Peer Review File

Integrated biosensor platform based on graphene transistor arrays for real-time high-accuracy ion sensing

REVIEWER COMMENTS</B>

**Figure R4**: Principal component analysis (PCA) of integrated ion sensing chip towards electrolytes comprised of different of ions using **a** Dirac Points and **b** extrapolated sensitivity as feature vectors.

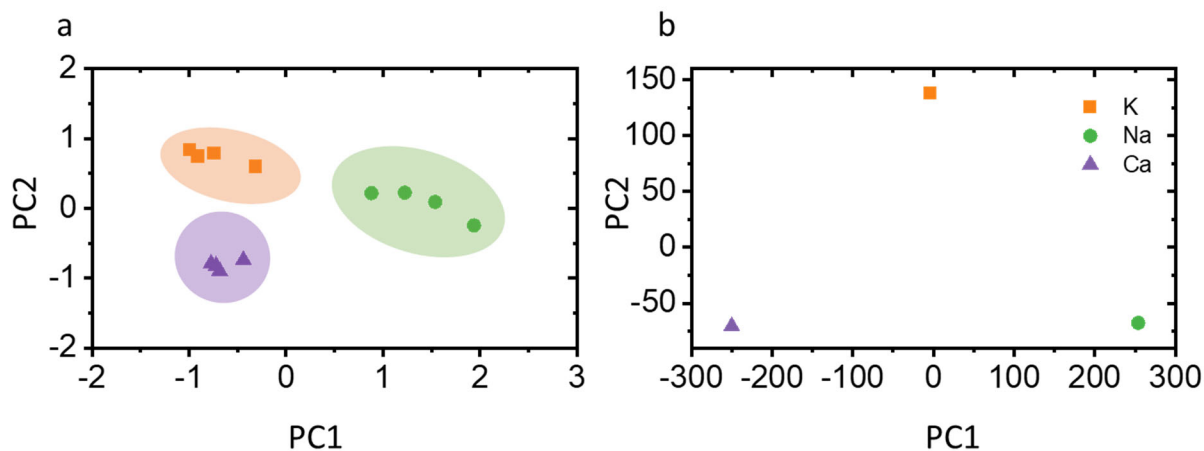
6. For the PCA, how many features were applied for the classification? The authors should clarify these features in the manuscript.

We appreciate the reviewer's question. The number of features (dimensions) equals to the number of working devices on the sensing chip. PCA was used to reduce the dimensionality from >200 to 3 principal components. We performed two separate PCA analysis with

We modified the main text and added a paragraph explaining the details of PCA in the methods as: "*We first performed Principal Component Analysis (PCA) using the Dirac Point of individual devices as features to visualize the multivariate data under a lower dimensional space while preserving the largest variance. The first two principal components (PC) accounted for 92.1% of the total variance in the data. The score of PC1 and PC2 is plotted in Fig. 3e and the details of the PCA analysis are explained in Supplementary Note 7. The clusters of K^+, Na^+ and Ca^{2+} ions are well-separated, indicating the sensor's ability to distinguish between different types of ions in electrolyte. Further separation can be achieved by using the ion sensitivities of individual sensors as the feature set as shown in Supplementary Fig. 20.*"

Figure R6: Dirac Point drift of K ISM functionalized sensors over a week showing the necessity of fast and easily calibration schemes.

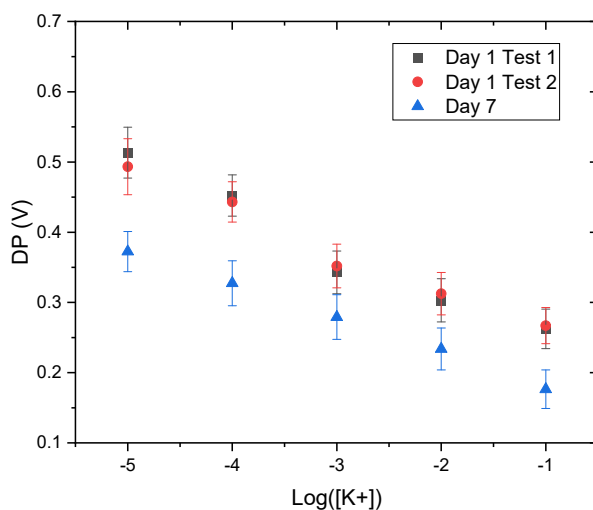
9. The authors claimed that only one reference solution was need for the determination of ions in a unknow sample with the profile-matching calibration. Is a reference solution always essential for the calibration in each test, or not needed any more after the calibration of sensor with the reference? In addition, what was the concentration of reference for the calibration in Figure 2i? Should the concentration of reference always fall in the linear range?

We thank the reviewer for this comment. Calibration is essential for almost all sensing systems in order to have precision and reproducibility[R10]. Sensor accuracy can deteriorate through wear, aging and environmental influences and should therefore be recalibrated at regular intervals. Similarly, our ion sensor arrays will also need to be re-calibrated due to unavoidable drift over time due to graphene's property change in ambient air. Shown in Fig. R6 is the extracted Dirac Point of a K^+ ISM functionalized array for tests within the same day and tests within a week. Negligible drift was observed for the two tests in the same day. Noticeable drift was present for the measurement after a week, where a re-calibration was necessary for accurate measurement. A general rule-of-thumb for accurate results is to re-calibrate if measurements are not done in the same day. Traditionally such re-calibration would require multiple calibration solutions. With the profile-matching technique proposed in the manuscript however, only one calibration solution is needed as long as the sensitivity is stable over long period of time. We have showed the stability of sensitivity for up to 6 months as shown in Fig. R2b.

Concentration of reference solution indeed need to be within the linear range because we are utilizing the quasi-linearity in graphene's *I-V* curves. The linear range for our ion sensors is wide enough (5 order of magnitude) for most applications. The reference concentration used in the manuscript is 1mM. The following modification is made to the main text and supplementary information:

Figure R9: Average membrane thickness over an area of 2.5 mm × 0.5 mm printed by the material jetting printer with different printing pressure. Five measurements were taken with a digital caliper across each membrane strip.

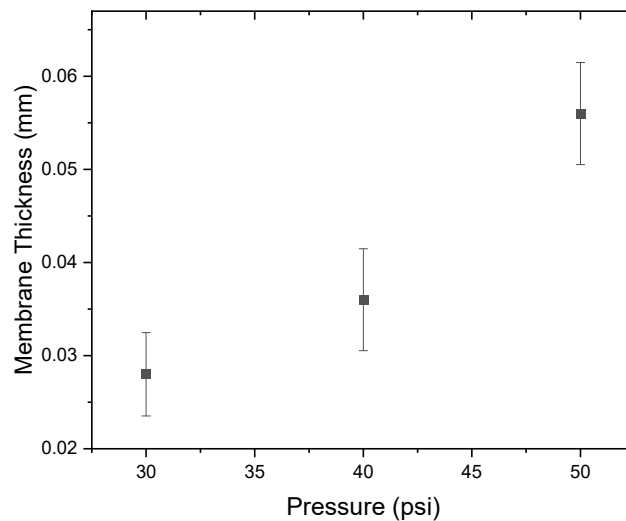
2. Material jet printers are used to deposit various chemicals onto the sensing area with precise lateral control. To what extend the printers can control the uniformity of the functionalization?
Our response:

To address reviewer's comment, we have included Fig. R9 as Supplementary Fig. 18 and covered it in the Methods as *"We adjusted the applied pressure to 20-30 psi and the stroke to 60% - 70% (percentage of voltage drop during the valve actuation) with the closed valve voltage of 100 V. The membrane uniformity over an area of 2.5 mm × 0.5 mm is characterized and shown in Supplementary Fig. 18.*

Figure R14. *I-V* characteristics of graphene sensor array tested in water (yellow curves) and in human serum (blue curves).

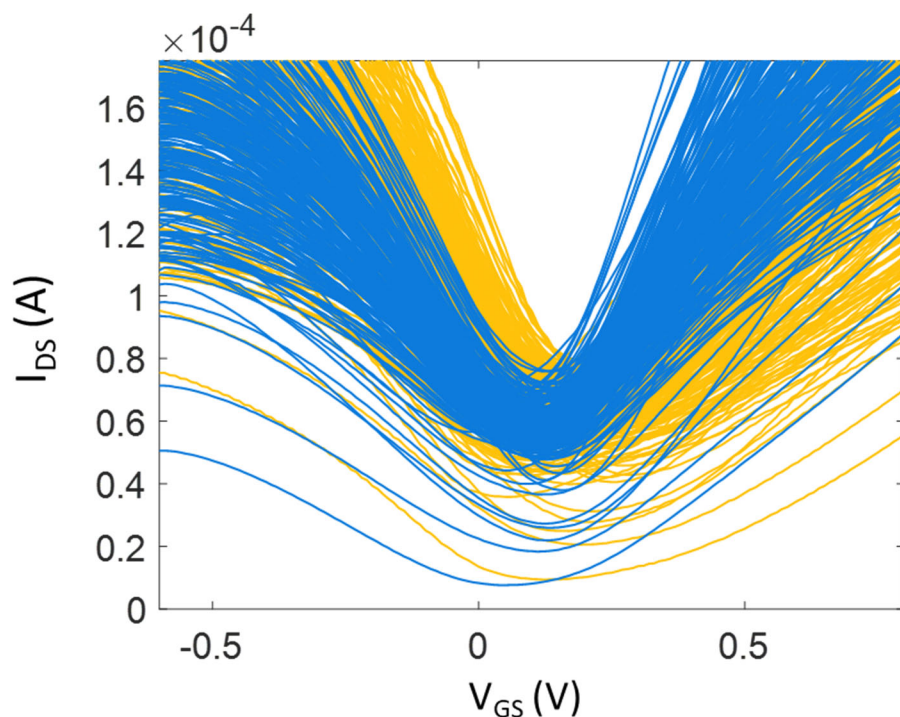
5. In Algorithm-enhanced sensing accuracy section, the authors should clarify if the multi-ion solutions used in the second set of experiments were in water or AU/AEP. It would be better if the authors could provide the sensing performance and classification results with real-world biological samples to support the practical significance of the sensing platform. Or the authors should at least discuss on how the sensing performance and data analysis could be affected due to the complexity of real-world biological samples.

We performed the *I-V* characterization of the as-fabricated graphene sensors in human serum and the result is shown in Fig. R14. The sensing chip is still fully functional in real bio-fluids with a high yield of 239/256 devices. A significant shift of the *I-V* characteristics is observed from the baseline measured in water, due to the change in ionic strength and the presence of proteins and steroids. This result shows that the sensing chip is robust enough to function in real bio-fluid and to have the same reliable measurements and potentially high functionality as we have demonstrated in the main paper. We have added the Fig. R14 as Fig. 4f in the main text.

Figure R3: **a** *I-V* characteristics of graphene sensor array tested in water (yellow curves) and in human serum (blue curves). **b** confusion matrix for electrolyte imbalance classification in mixture solutions using integrated graphene sensing chip.

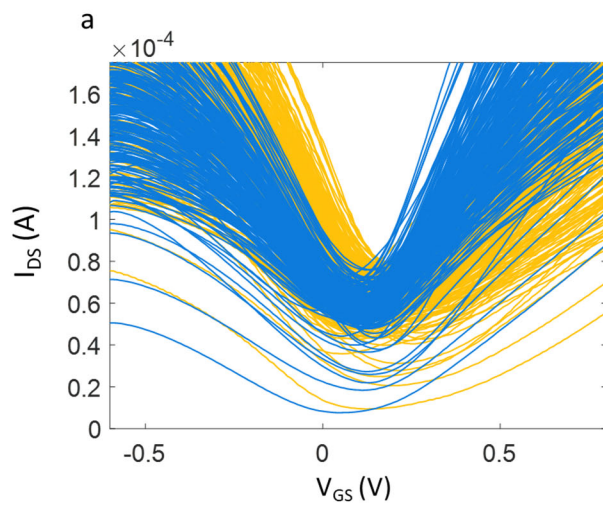
It is a very well written paper but real time monitoring of real sample can't be demonstrated by using simply urine samples... Two questions: sensing in plasma fluids are in presence of a high

(9g/L) of NaCl concentration and in presence of complex mixture of proteins. The high concentration of salt should decrease the sensitivity of FET sensing scheme, how do the authors aim to overcome this? Same question in a complex fluid with grams per millilitre of serum albumin, sugar, etc.

The confusion matrix of the result model is shown in Fig. R3b below. We achieved an average accuracy of 84.7% for classification of ion concentration profiles with solutions containing multiple ion types. The model is less confident at identifying higher calcium and higher potassium. It could be due to the imbalanced training data in such classes, i.e., there are fewer observations with a higher calcium/potassium level that make the learning harder. This analysis demonstrates the possibility of coupling the multiplexed sensing array with machine learning models to achieve fast and high accuracy of electrolyte imbalance-related disease diagnosis. The performance of the
